RFT 26-083 Interior Renovations & Air Conditioner Upgrades at Frontenac PS

The following, issued by the Halton District School Board (HDSB) June 18, 2026, shall be incorporated in the specifications and shall form part of the proposal document for the above.

TENDER ADDENDUM NO. 1
2026.06.17

Interior Renovations and Air Conditioner Upgrades at Frontenac Public School
Halton District School Board RFT 26-083
5140 Pinedale Avenue, Burlington, Ontario

Drawing No.:
E3.8

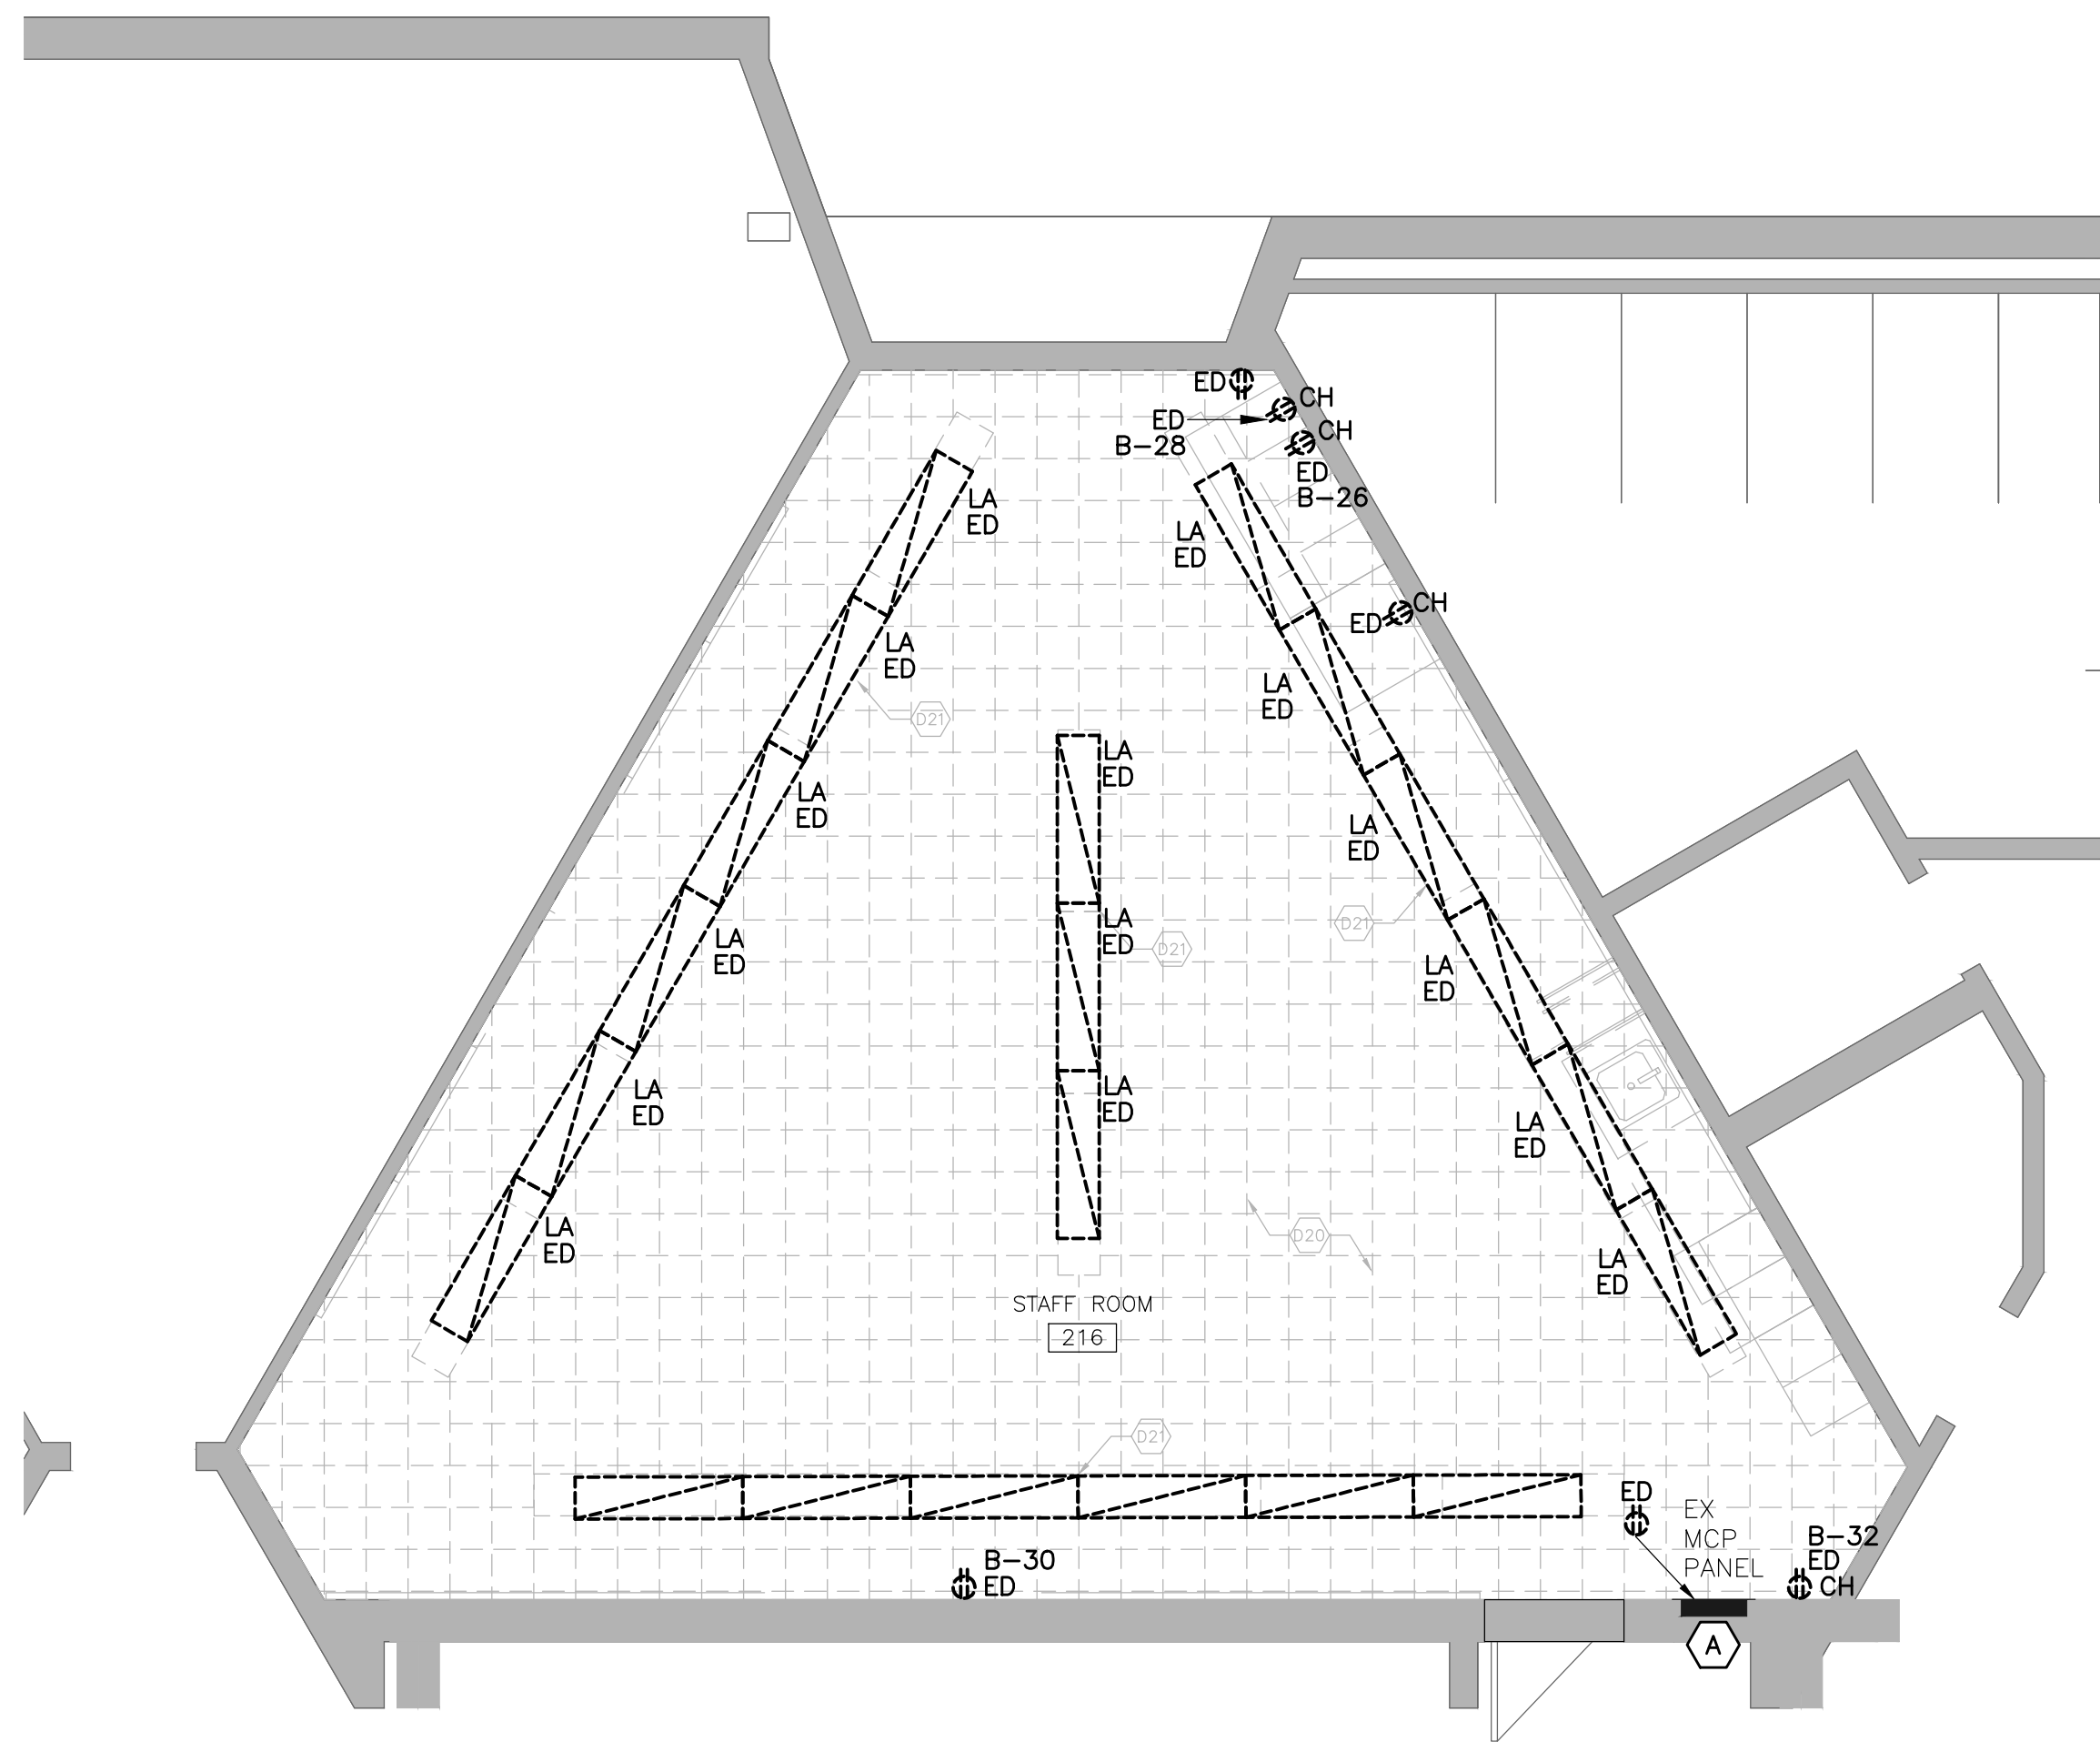
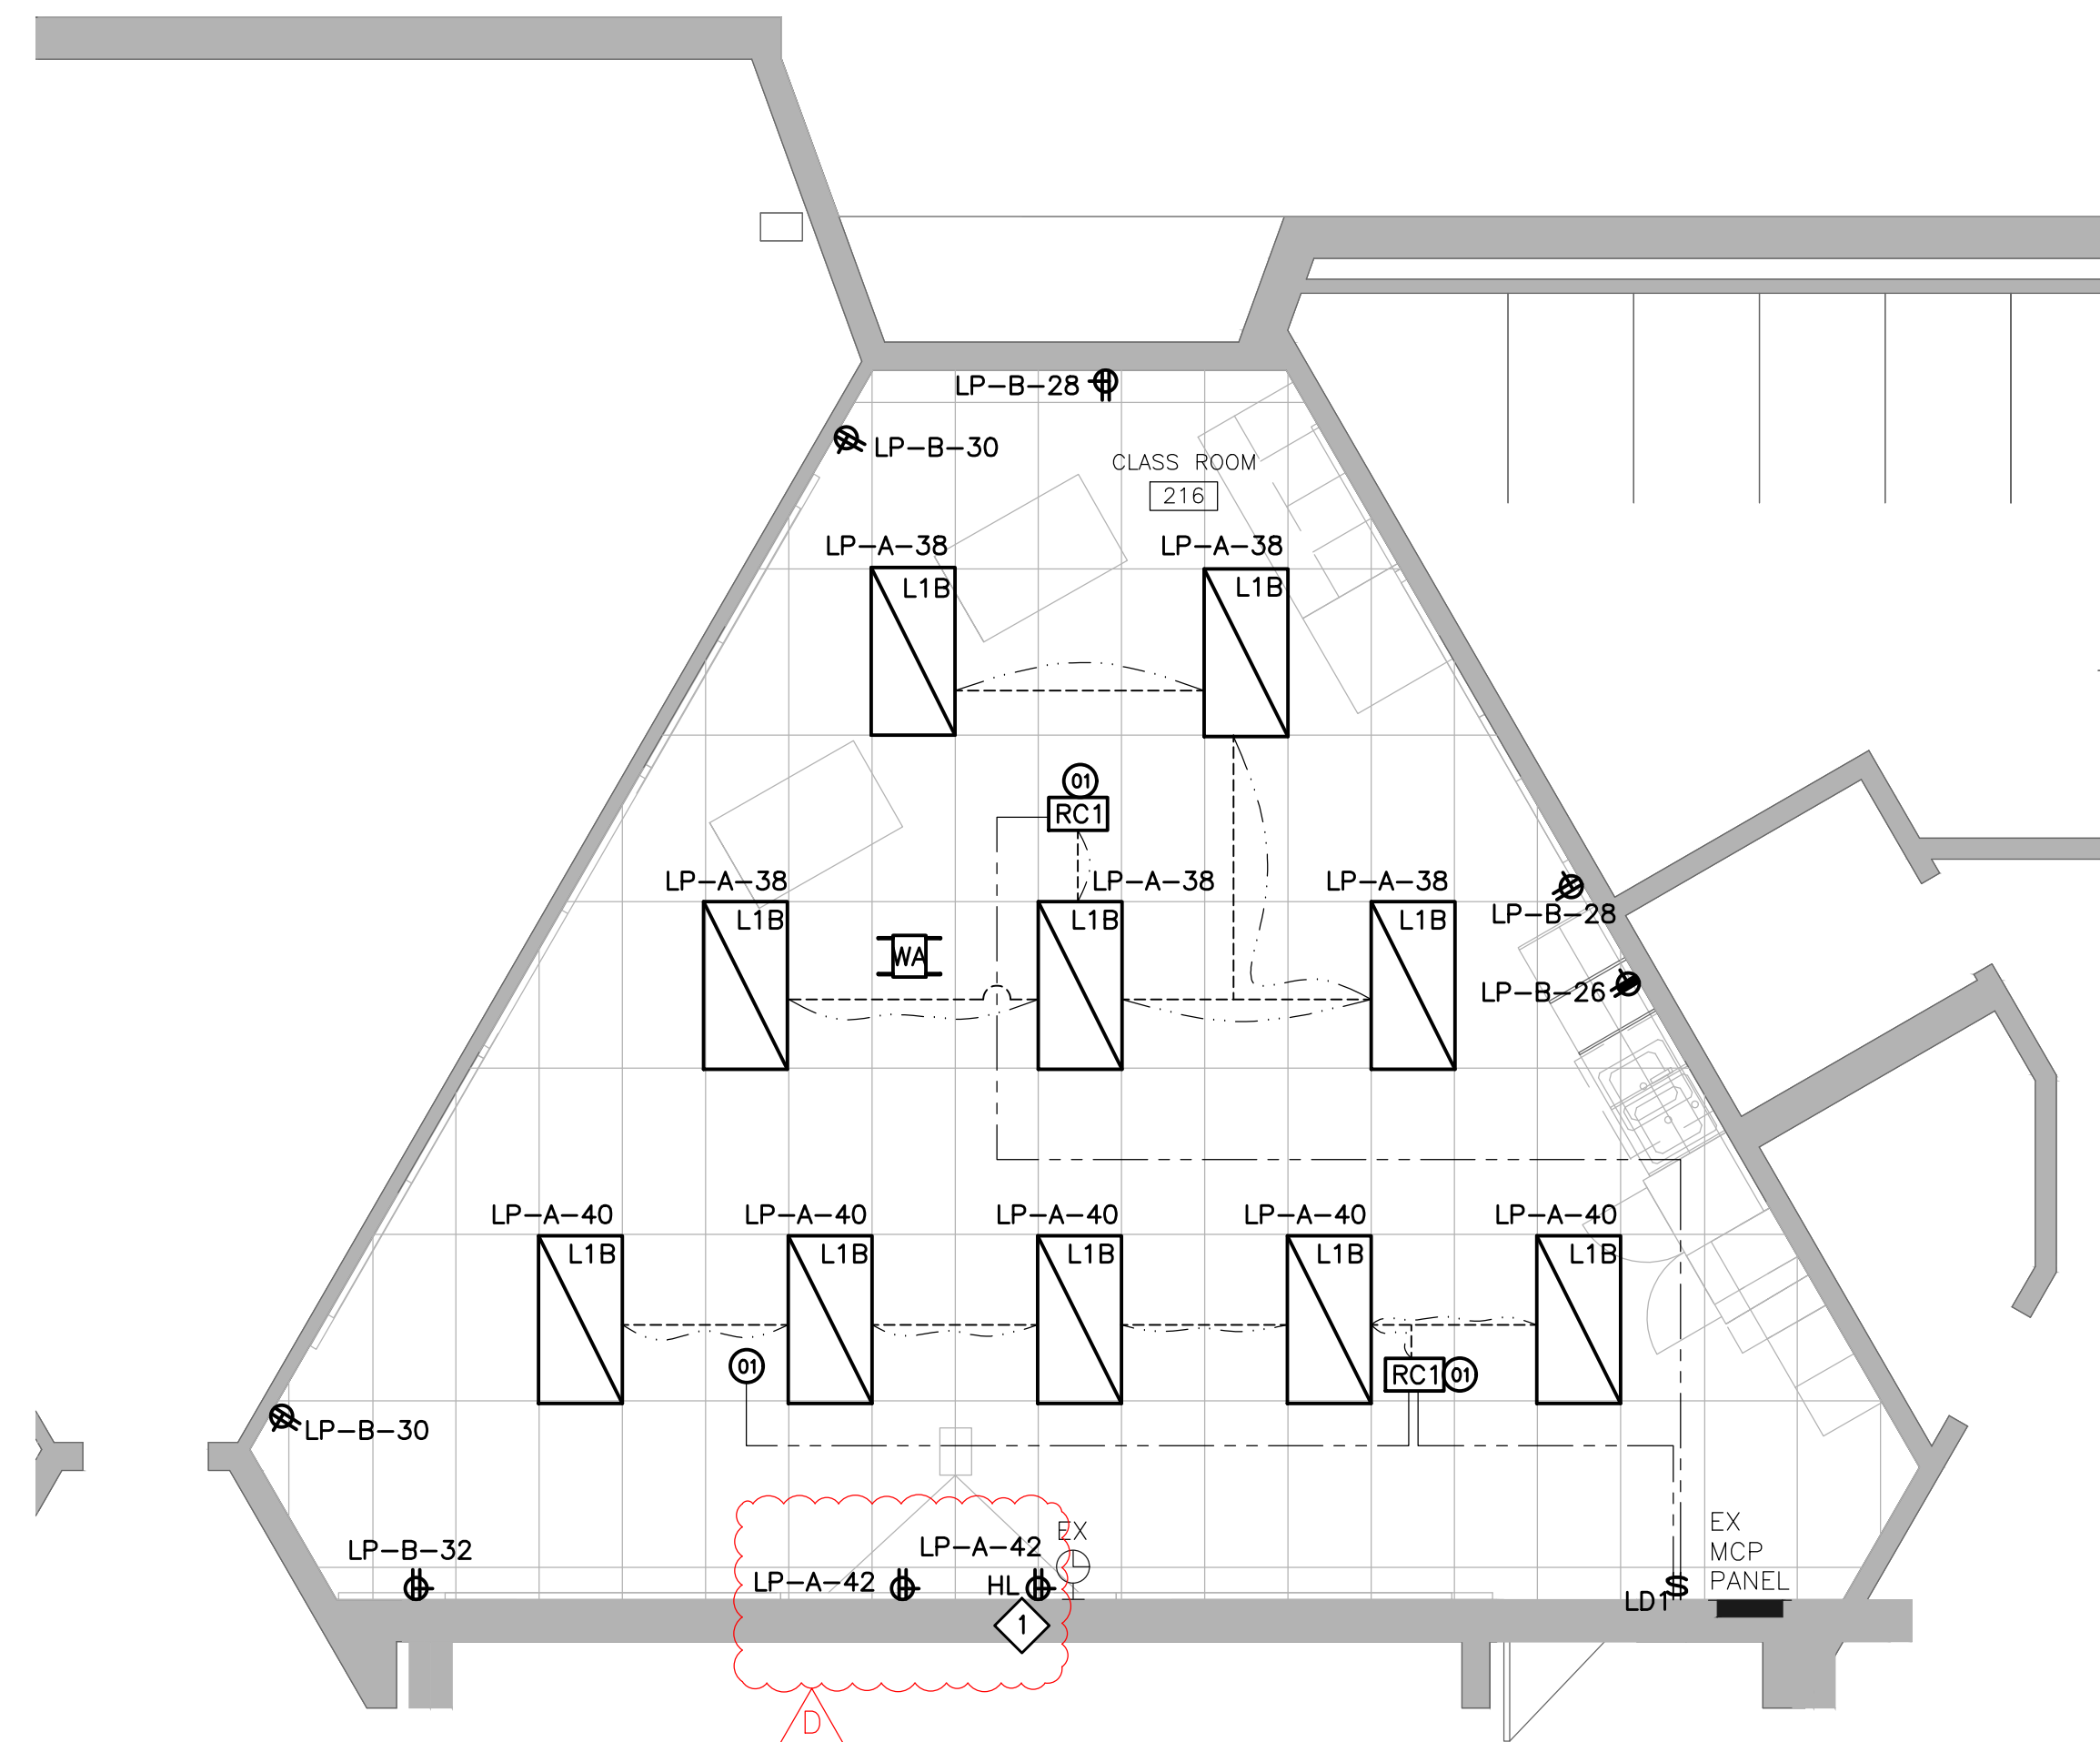
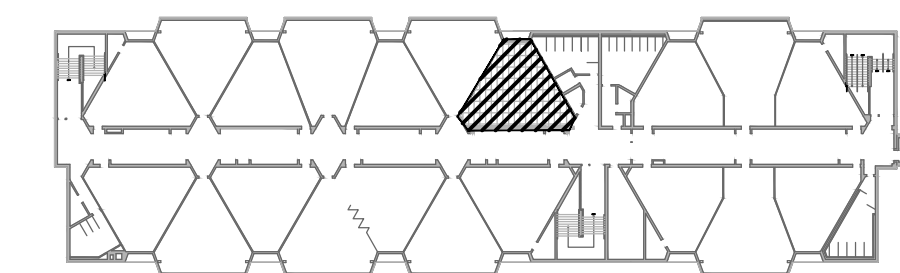
1.10 Refer to revised Electrical Drawing 3.8 Rev.D

- Revised drawing keynote 1.
- Revised the projector receptacle to 20A.
- Added another receptacle for the projector.
